SHADYBROOK COMMERCIAL COMMUNITY UNIT PLAN

Dated August 29, 2005
APPROVED CUP
MAPC Per Admin Adjustment
CUP25-30 1 of 4

RE: CUP2025-00030 – Administrative Adjustment in the City to the Shadybrook Commercial CUP DP-210 to permit one freestanding sign to face parallel to the adjacent street and modify sign base construction materials, on property zoned LC Limited Commercial District; generally located on the south side of East 21st Street North and within one-block west of North Hillside Avenue (3051 E. 21st Street North).

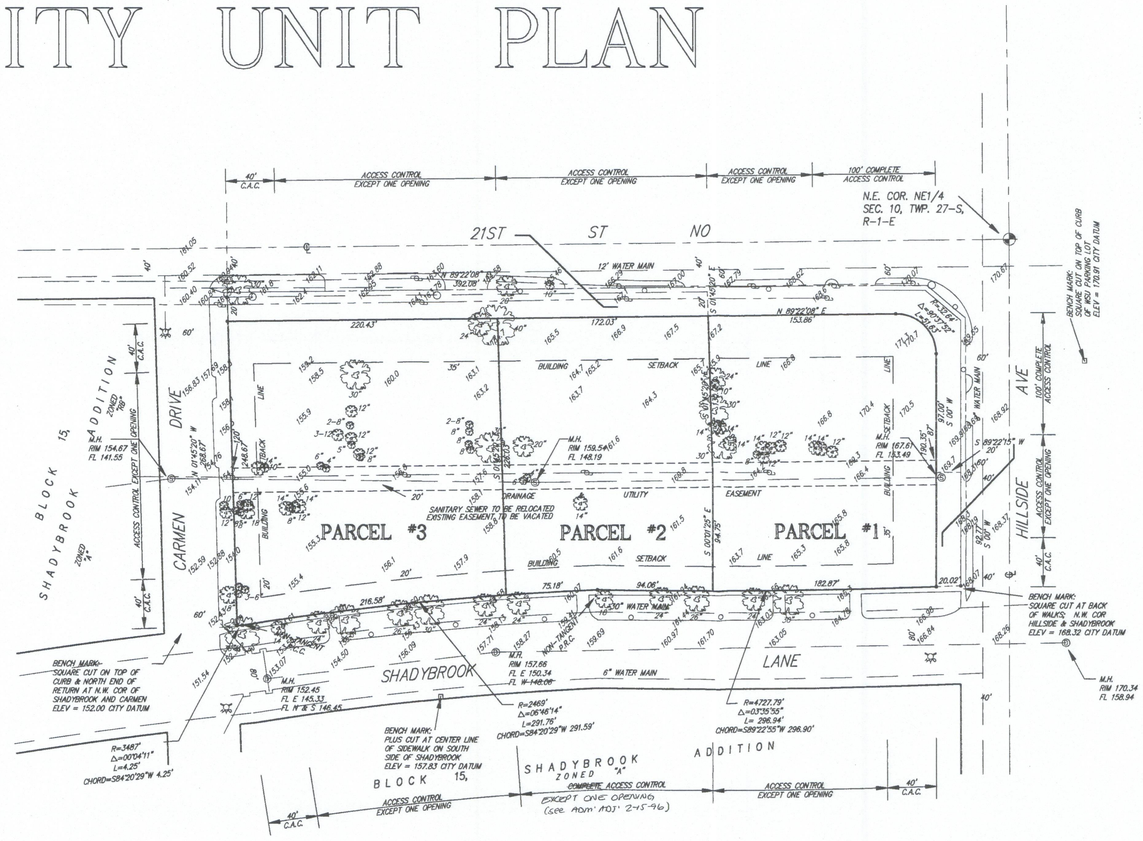
We received and reviewed your request for Administrative Adjustments to CUP DP-210 to permit one freestanding ground or pole sign on Parcel 2 to face parallel to the adjacent street right-of-way and to modify General Provision 7 to modify permitted building materials for the base of the sign. The purpose of the request is to enhance visibility of the Maya Angelou Library location with a unique custom-designed sign for this specific library branch. The design of the sign was intended for a parallel orientation on the site because the topography of the site slopes down, away from East 21st Street North, which creates challenges for a perpendicular orientation of the sign.

The application proposes adding stipulation "e," which would state: "One monument sign is allowed on Parcel 2 to be parallel to the street."

It is also proposed to modify General Provision to exclude the proposed sign on Parcel 2 from having a brick base. Below is the staff recommended modified text for General Provision 7.

e. One monument sign is allowed on Parcel 2 to be parallel to the street.
7. Red brick shall be used in a prominent manner in the exterior design for all parcels, e.g. on building elevations, as the base for ground signs, and/or on the face of any retaining walls. The use of cast stone trim is also encouraged. All roofs visible from the street shall be of hipped construction. The monument sign base for Parcel #2 may have a concrete base.

7. Red brick shall be used in a prominent manner in the exterior design for all parcels, e.g. on building elevations, as the base for ground signs, and/or on the face of any retaining walls. The use of cast stone trip is also encouraged. All roofs visible from the street shall be a hipped construction. The monument sign base for Parcel #2 may have a concrete base.

On the basis of our review, we find that adjusting the CUP to permit one freestanding ground or pole sign to face parallel to the adjacent street right-of-way and permitting the sign base to be concrete is consistent with the approved CUP and will not have an adverse effect on the CUP or adjacent properties, nor will it be a substantial deviation of the original plan. The existing topographic conditions of the site make a perpendicular ground sign challenging. The proposed sign plan illustrates the sign would be setback from the property line, which increases the visibility of the sign face. No Parcel within the CUP has a ground or pole sign currently erected along East 21st Street North so a sign on Parcel 2 with a concrete base would not be inconsistent. Furthermore, the building was constructed with a significant amount of red brick, and a concrete sign base will not detract from the overall architectural style within the CUP. Therefore, staff does not think that permitting a freestanding ground or pole sign parallel to the adjacent street right-of-way will have significant detrimental effects on nearby properties.
